**Pacific Gas and  
Electric Company®**

PG&E Letter HIL-12-003

Docket No. 72-27, Materials License No. SNM-2514  
Humboldt Bay Independent Spent Fuel Storage Installation  
License Amendment Request 10-01, Revision 1  
Revision to License Condition 7.B

## EVALUATION

REVISION DESCRIPTION 8/23/12 REVISED FOR LAR 10-01 REVISIONS	HUMBOLDT BAY POWER PLANT - PG&E CO.		
	PROCESS WASTE CONTAINER FSAR FIGURE 3.3-5		
DRAWING DSK-RXV-042	SHEET 1 of 1	REV 1

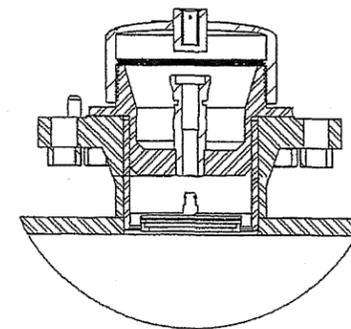
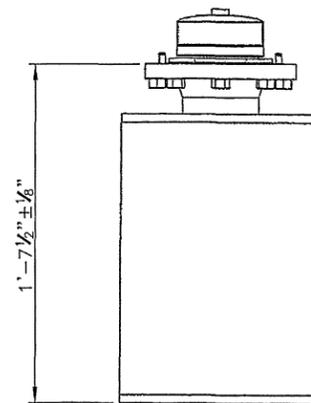
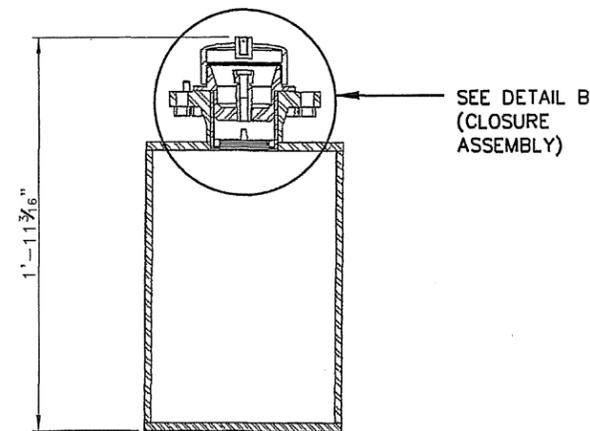
PG&E changed the design of the Process Waste Container (PWC) that will store the GTCC process waste since the original LAR 10-01 submittal. The PWC design has been modified to replace the welded lid with a mechanically sealed lid. This design change was needed because welding the lid was difficult due to the high dose environment.

*(PWC), shown on Figure 3.3-5. The PWC is a stainless steel, cylindrical container, approximately 12 inches in diameter and 24 inches high and will be mechanically sealed, vacuum dried, backfilled with helium and leak tested. The PWC will be placed within the Outer Container inside the GWC. The Outer Container is designed to provide stabilization for the PWC. A lid will be placed on top of the Outer Container. The activated metals will be placed inside the GWC and outside of the Outer Container. Therefore, the process waste is prevented from co-mingling with the GTCC activated metals.*

REVISION DESCRIPTION	HUMBOLDT BAY SFSI GTCC DASK ASSEMBLY OVERVIEW FSAR FIGURE 3.3-4		
8/23/12 REVISED FOR LAR 10-01 REVISION 1	DRAWING	SHEET	REV
	DSK-RXV-037	1 of 1	1

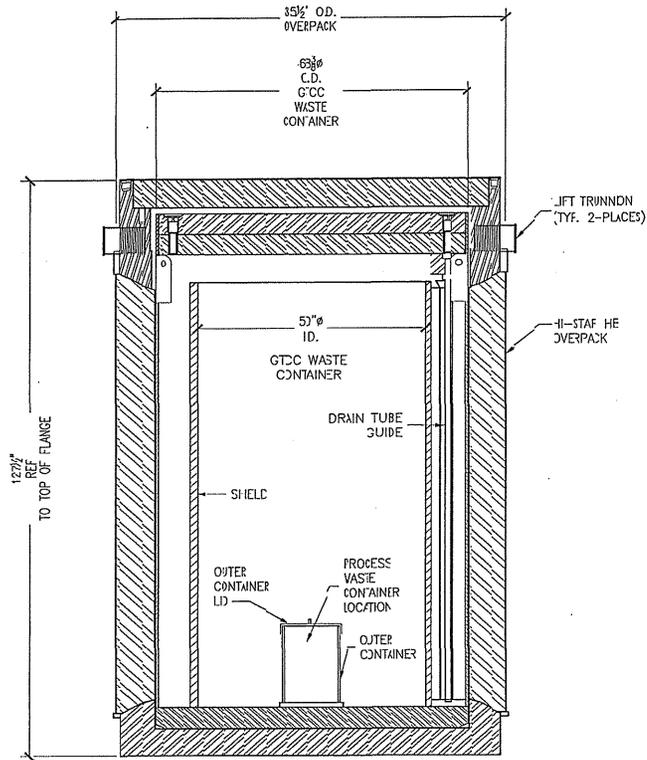
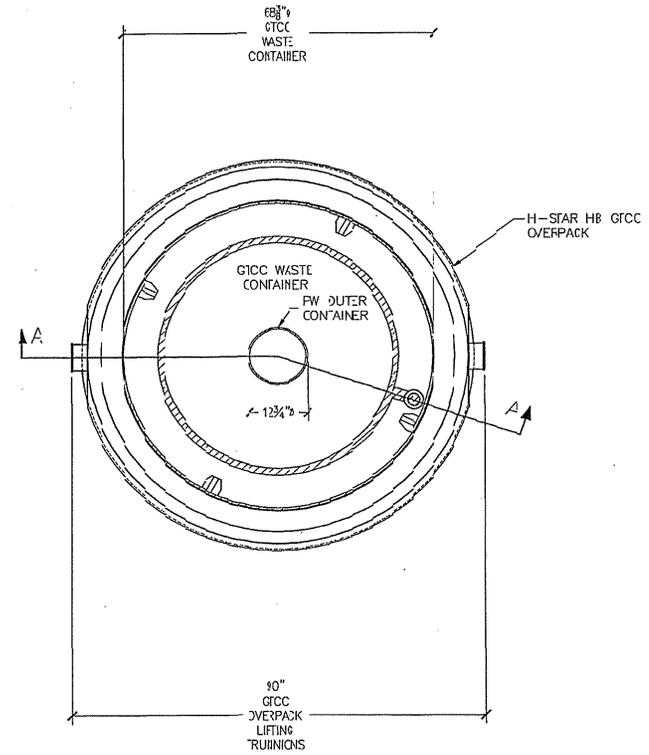
The elimination of grout from the design also eliminated a measure of stability provided for the activated metal pieces that will be loaded in the GWC. However, the activated metal pieces will be loaded using a loading plan that strategically places the pieces in a configuration that minimizes movement and potential secondary impacts. The activated metal pieces will be loaded into the GWC vertically, and the GWC will remain in the vertical position within the HI-STAR HB GTCC Overpack during transfer from the refueling building to the ISFSI and during storage in the ISFSI.

**As shown on Figure 3.3-4, the GWC is contained within the HI-STAR HB GTCC Overpack. The GWC is similar to the Multi-Purpose Canister (MPC) within a spent fuel cask. Also shown is the Outer Container that is welded onto the bottom of the GWC. The process waste will be contained in a Process Waste Container**
